SUBJECT: **RFQ FOR DESIGN-BUILD SVCS FOR HORIZONTAL/CIVIL ENGINEERING PROJECTS**

SUBJECT: CDB-0006-16 – Design-Build Services - Horizontal & Civil Engineering – Times Union, Pearl Street- Coastline Drive West Realignment
AMENDMENT 28B PO 600668-20

Re: Proposal for West Coastline Drive Realignment @ Times Union Performing Arts Center Design-Build Construction Delivery for City of Jacksonville-City Contract No. 6533-54

From: Bob Baxter [mailto:r.baxter@gaiconsultants.com]
Sent: Thursday, December 19, 2019 9:54 AM
To: Reed, Nikita
Cc: Jayson Smith; Randal Thompson; Nick Mousa
Subject: WEST COASTLINE DRIVE 90% PLANS Submittal

TYPICAL SECTION

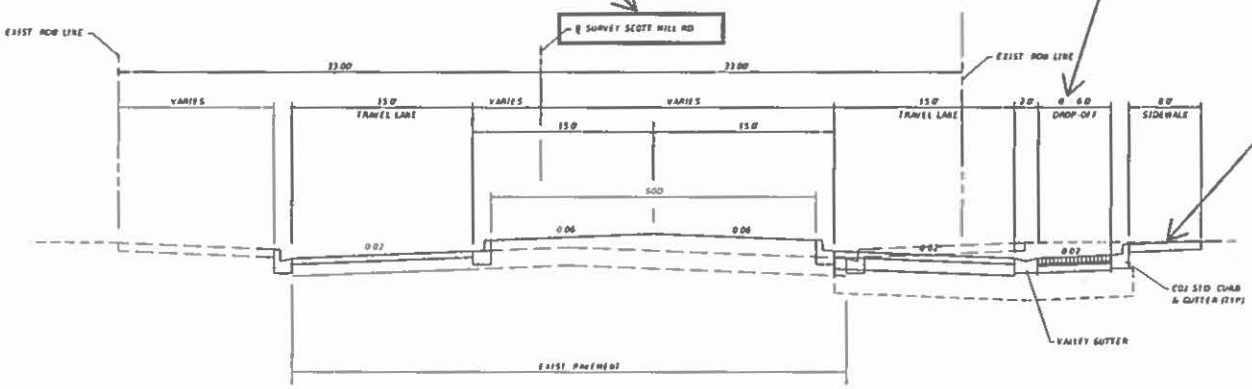
6' seems very narrow for drop off. Consider options to widen another 2'.

Revise

Label max slope on sidewalk

- Need a typical section for the driveway portion
- BL survey labeled Scott Mill Rd. – Sheet C-2
- Need cross section of valley gutter showing slopes/dimensions – Sheet C-2

- Indicate slopes as minimums (or as appropriate if not minimums) – Sheet C-2
- Sheet C-3 indicates Std. Curb and gutter around the vegetation island. Should this be a median curb?

- Include sidewalk details on Sheet C-2
- Does the valley gutter extend across the driveway between points 17 and 19?
- Need a pavement marking/traffic control device plan (FDOT APL thermo? Marking width and location?, Do Not Enter signs? No parking signs in drop off area?). Should comply with FDOT standard specs.

- Need pavers details for drop-off area – Sheet C-2
- Fountain piping also needs to come out as part of demolition – Sheet C-4
    - Specify contingency fill material type

We have a few more comments on the attached doc. Sorry for sending them separately. Don't worry about the drop off comment on Sheet C-2. I know what we are working with there. And same comments as before about the % development. When Mike and Kelsey were looking at this, they thought these were intended to be 90% plans.

PLAN VIEW	SHEET NO
COASTLINE DRIVE JACKSONVILLE, FLORIDA	C-3

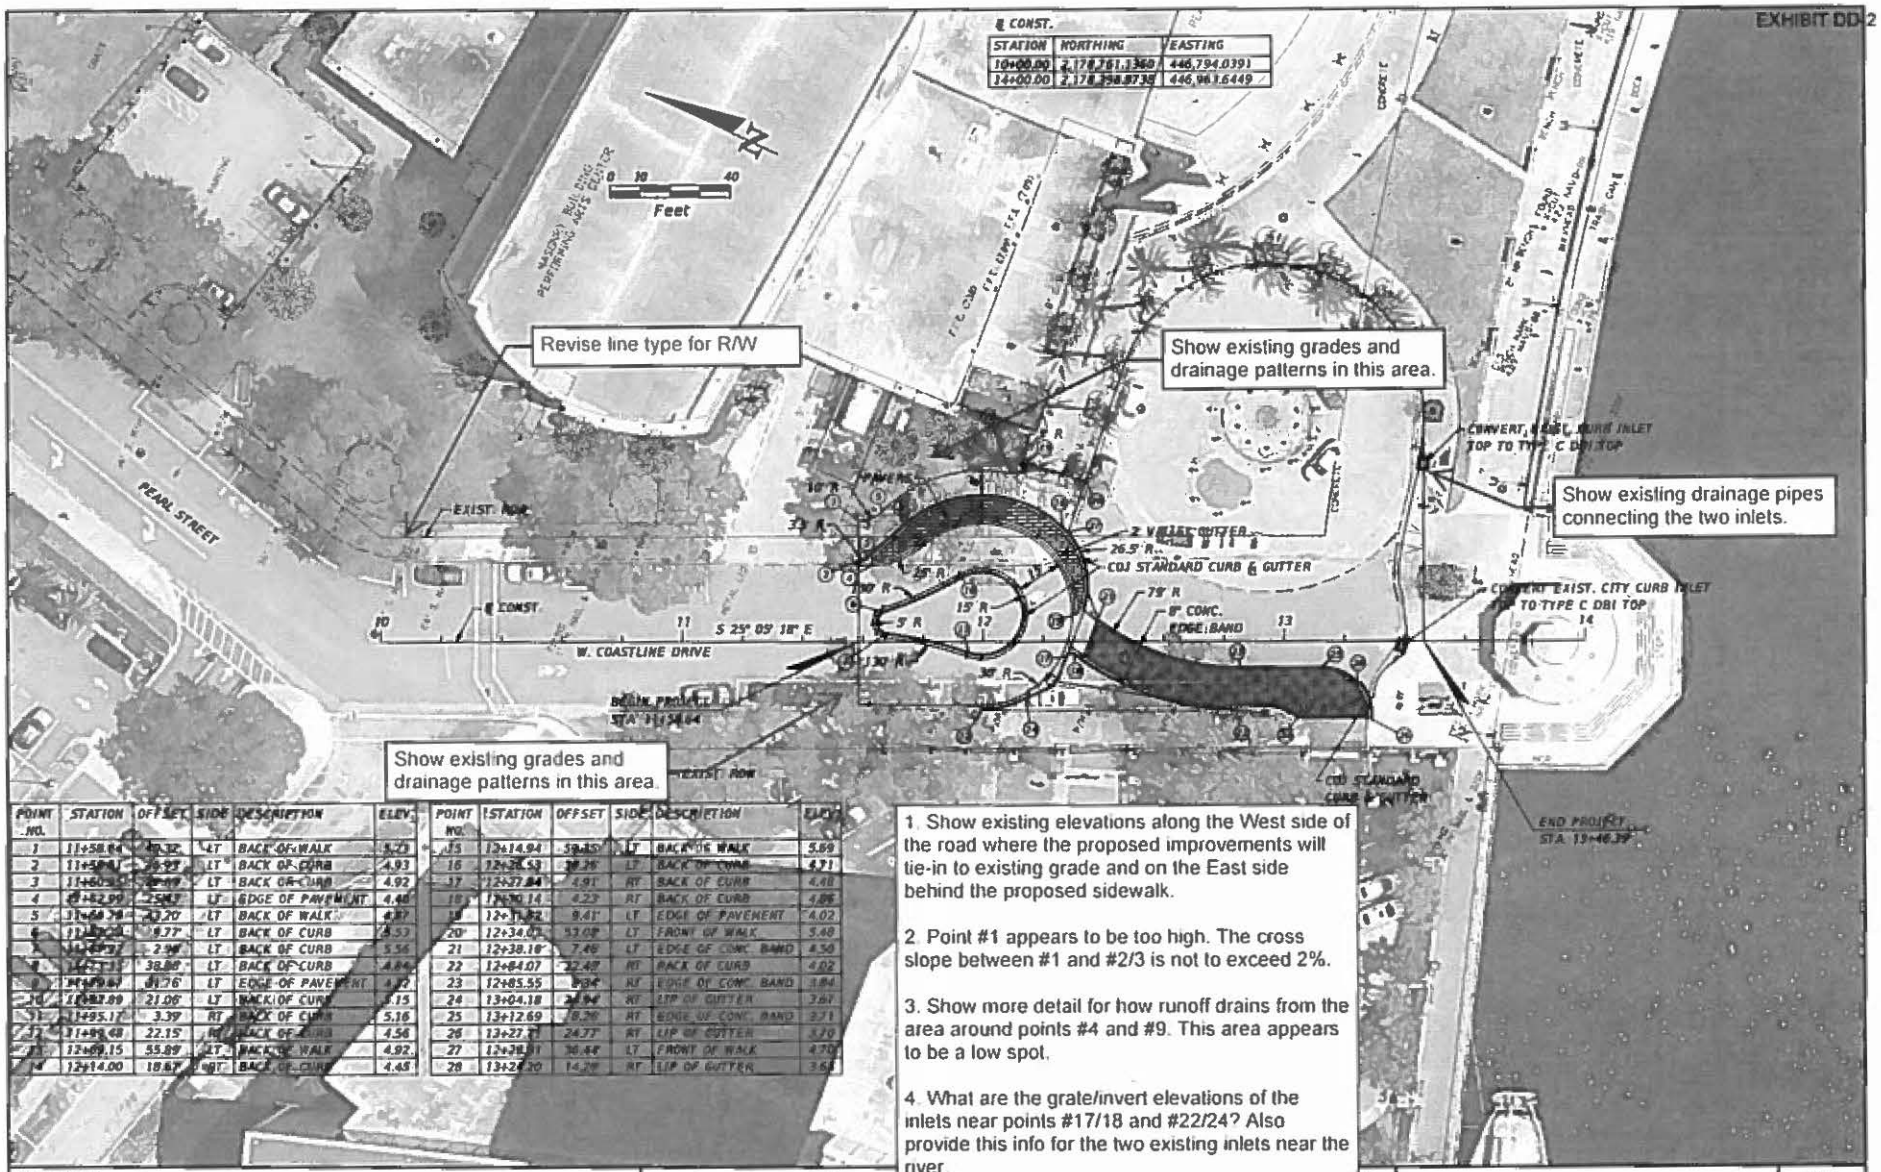
1. Show existing elevations along the West side of the road where the proposed improvements will tie-in to existing grade and on the East side behind the proposed sidewalk.

2. Point #1 appears to be too high. The cross slope between #1 and #2/3 is not to exceed 2%.

3. Show more detail for how runoff drains from the area around points #4 and #9. This area appears to be a low spot.

4. What are the grate/invert elevations of the inlets near points #17/18 and #22/24? Also provide this info for the two existing inlets near the river.

5. The slope between points #13 and #15 is not to exceed 5%.

- What are final elevations in unpaved areas?
- What are the inlet elevations? And are we changing the inlet types because the site elevations are changing? (We talked about this. But I forgot the answer.)

11.5 in. x 17.25 in. x 3.5 in. Concrete Grass Block Paver

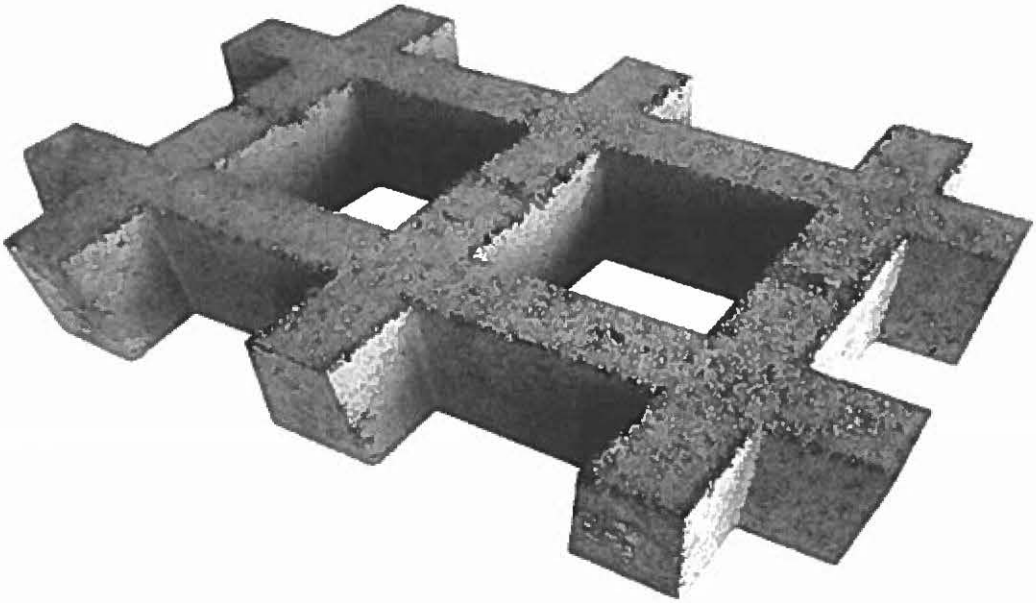
Were you talking about using the "grass block pavers" like this? Filling them with dirt and seeding it for grass to cover?

Yes. That's the kind of thing we want.
